Response to Further Advice – 12 Chalk Street, Wooloowin (Council Ref: A006835434)

Urbis Ltd continue to act on behalf of Cedar Woods ('the Applicant'), in relation to the abovementioned development application. This correspondence constitutes the Applicant's full response to the Further Advice issued by the Assessment Manager on 17 March 2026 for the development application, in accordance with Section 35.1 of the Development Assessment Rules (Council Reference: A006835434)

Figure 2 – Updated Shadow Diagrams

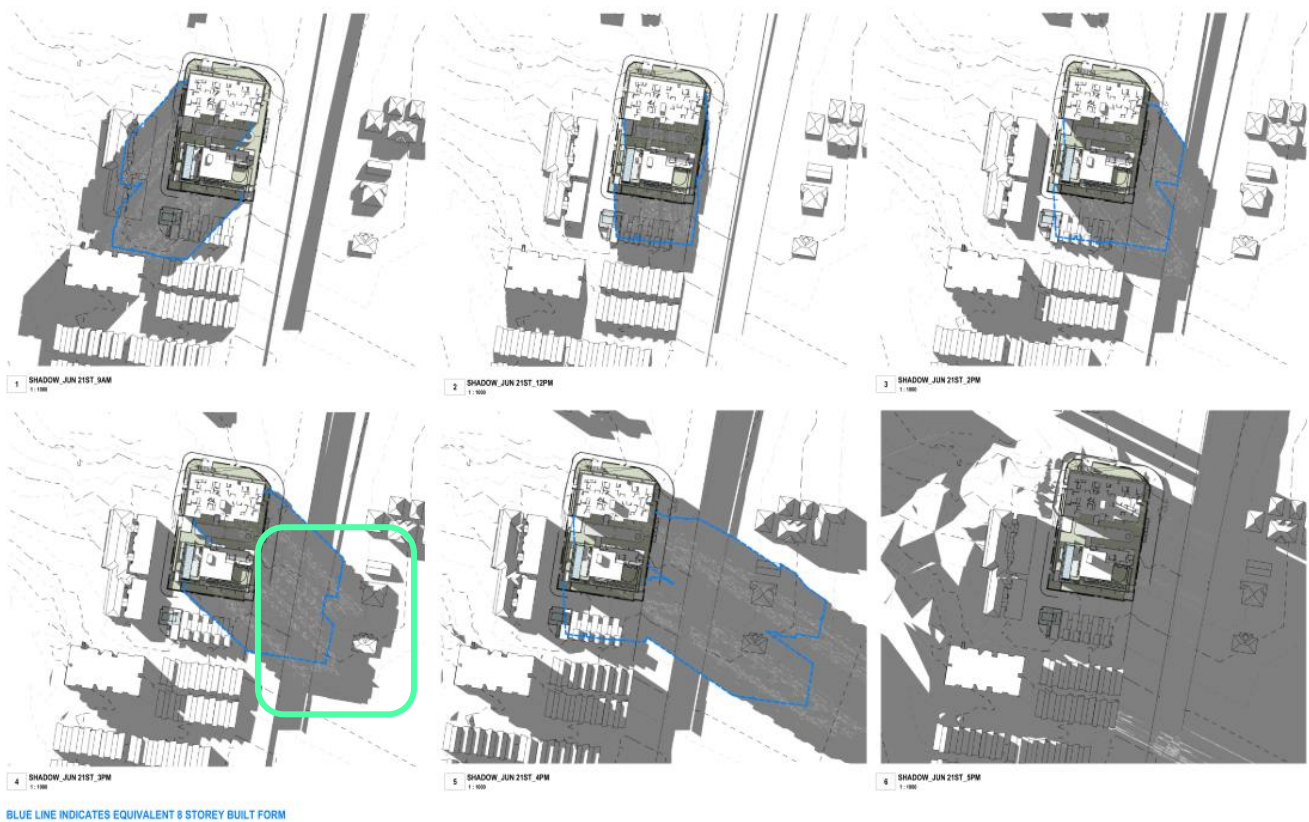
The comparative shadow diagrams provided in response to the Information request show additional overshadowing impacts from the proposal compared to a built form complying with the building envelope aspects of the assessment benchmarks. The response however does not provide detailed assessment of the impacts associated with the additional overshadowing and does not demonstrate how the proposal does not impact on the amenity of adjoining residents.

To allow for a full assessment of the shadowing impacts from the proposed developments height, provide further analysis of the additional overshadowing impacts to demonstrate the surrounding residences will continue to have access to adequate levels of natural light.

Please refer to the updated shadow diagrams in **Attachment A**, which now include hourly increments for the afternoon of 21 July, representing the worst-case scenario for overshadowing impacts. The diagrams compare the proposed development with an 8-storey development (refer **Figure 2**).

The analysis identifies additional overshadowing to two properties located to the east of the railway at 3pm on 21 July. Outside of this one-hour period, specifically prior to 3pm and after 4pm, the extent of overshadowing is consistent with that generated by a code-compliant built form. There is no increase in shadow impacts during the morning or around midday, when access to natural light is generally of greatest benefit to residential amenity.

The additional overshadowing occurs in the mid-to-late afternoon during mid-winter and does not result in a sustained or ongoing loss of sunlight to adjoining residences. The affected properties continue to receive

adequate levels of natural light throughout the day, including during earlier afternoon hours, and across the remainder of the year when higher solar angles reduce shadow impacts.

When considered in the context of an entire year, the additional overshadowing is limited to one hour on a single day and does not represent a material change to the overall solar access enjoyed by surrounding residences. On this basis, the proposal is not considered to result in an unreasonable impact on residential amenity or access to natural light, and the intent of the assessment benchmarks relating to building height and amenity is maintained.

Figure 5 – Approved townhouses and proposed separation

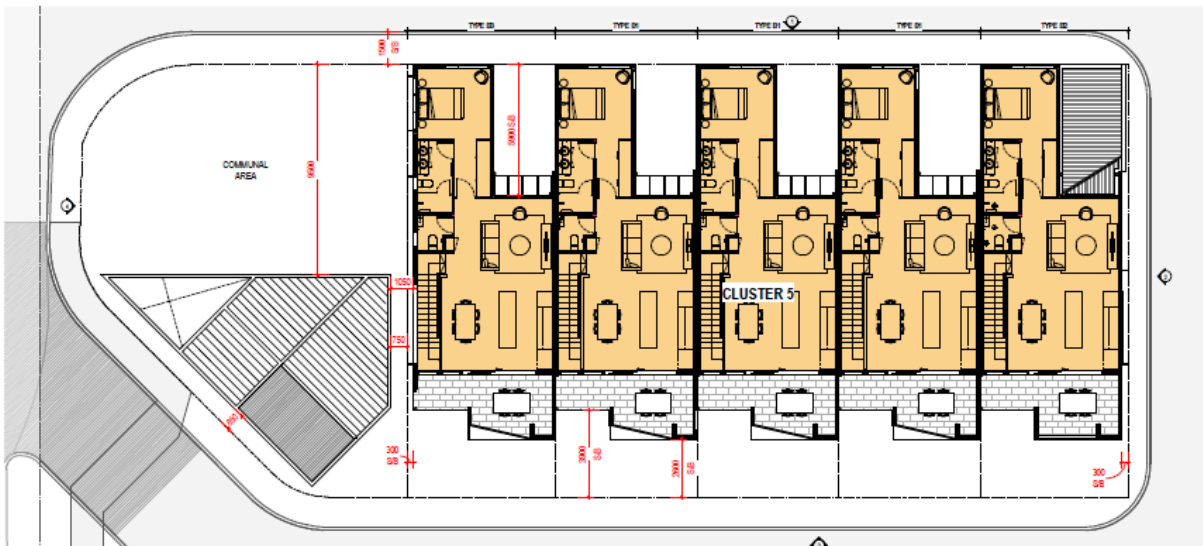
To understand how the development manages potential overlooking impacts to the adjoining residents, provide a plan detailing the separation distances between the development and adjoining buildings with

specific identification of the separation distances between balconies and habitable rooms/openings on each property.

Please refer to **Attachment A** for the updated architectural plans, specifically drawing DA-402 which provides detail regarding the separation to the adjacent approved townhouses (Council Ref: A006183051).

As illustrated in **Figure 2** below, the adjacent townhouses have a stepped configuration. The wall closest to the proposed development has a garage door on ground and a bedroom window on Level 1. The wall furthest from the proposed development has a bedroom window on ground and a living room window on Level 1.

The wall closest to the proposed development is separated 17.69m from the balcony line of the tower. The wall furthest from the proposed development is separated 22.06m from the balcony line of the tower. Pursuant to Table 9.3.14.3.F of the Multiple dwelling code, the building separation requirement for habitable rooms/balconies to habitable rooms/balconies is 3m on ground and 9m on Level 1. Accordingly, the proposed separation is compliant with the requirements of the Multiple dwelling code.
